Service Bulletin 2021-03#03 Risk Mitigation Measures on the Bobsled Coaster Vehicle Seat Compartment

Ride:	BC 2157 - Green Hornet
Object of Change:	1093-01-00-00-00
Reason for Information:	Mitigation of risks associated with intentional misbehavior of passengers.
Reason for Change:	In case of intentional misbehavior and physical capabilities of the passenger, it may happen that stationary objects installed on the side of the track could be reached and an impact may occur. This can result in serious injuries.
Measures to be taken:	<p>A: Information of passengers: Reevaluation of operation and use risk assessment of the ride in order to increase awareness of the passengers for the ride's safety rules.</p> <p>B: Mechanical adjustments: A proposal is issued by this service bulletin to add additional entrance panels to the vehicle entry and exit side openings.</p>
Regular Tests	Independent of the following described modifications, tests which are shown in the operating and maintenance instructions remain valid.

Figure 2: Entrance panels at the lower area in the front row

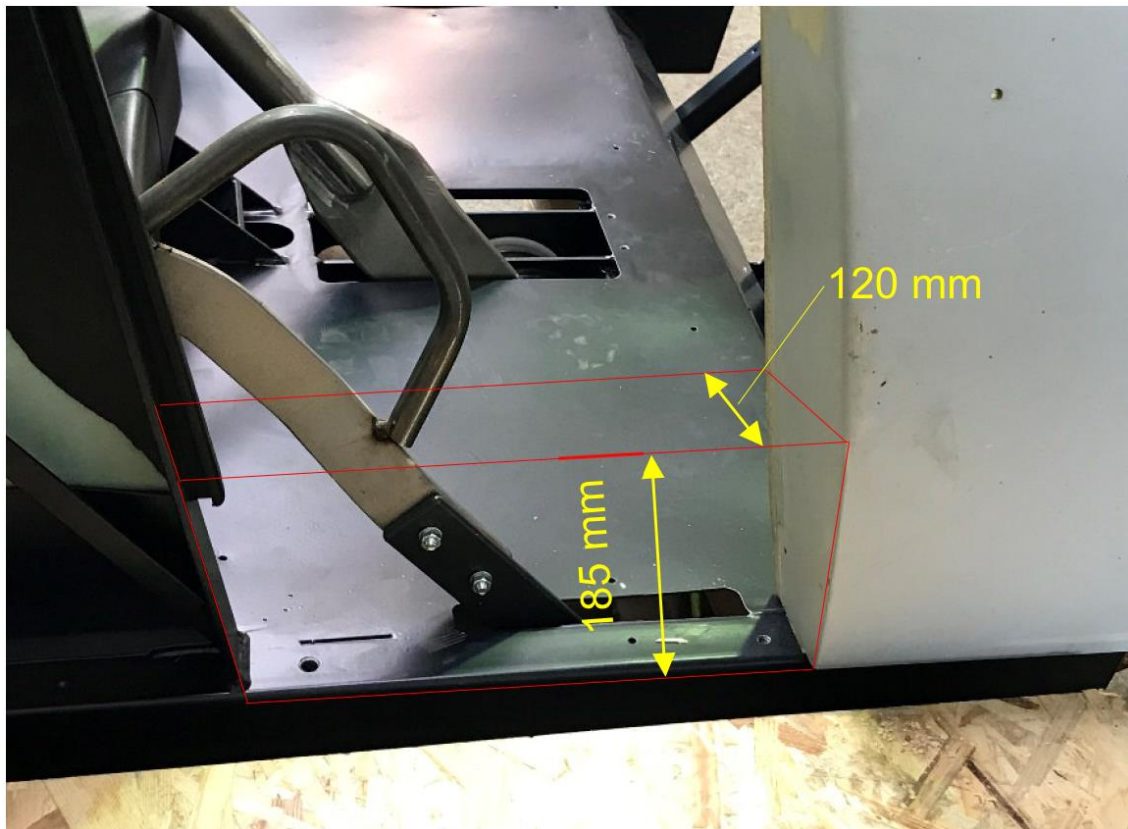
Together with a third party, it was investigated that a higher threshold in the lower area of the entrance and exit opening of the vehicle makes it more difficult to reach stationary objects installed on the side of the track with the toe of the foot. However, it shall be noted that this might create a tripping hazard during embarking and disembarking the vehicle. Therefore, the ride operator must evaluate in its own operation and use risk assessment these two risks since the tripping hazard might be influenced by the ambient condition of the station (e.g. lighting, color of floor, contrast between vehicle and floor etc.)

The proposed entrance panels shall have the following dimensions:

- Height of 185 mm
- Width of 120 mm (viewed in the lateral direction of the vehicle)

according to Figure 2.

The shape of the entrance panel may vary due to different vehicle body designs. The entrance panels shall be installed at both rows and both sides filling the entire clear width of the openings.

Reaching stationary objects installed on the side of the track with these entrance panels installed might be still possible but it requires even more effort to:

1. extend the foot beyond the outer contour of the vehicle and
2. extend the foot further down (extension opposite lower leg).

Therefore, the risk of a collision with stationary objects installed on the side of the track is minimized but not eliminated.

Since the vehicle FRP is custom designed and varies from ride to ride, a custom designed solution for this additional entrance panels must be used. Therefore, we cannot offer a standard additional entrance panel. We can support you in the design and the fabrication of these panels if your operation and use risk assessment comes to the conclusion that these panels shall be installed.
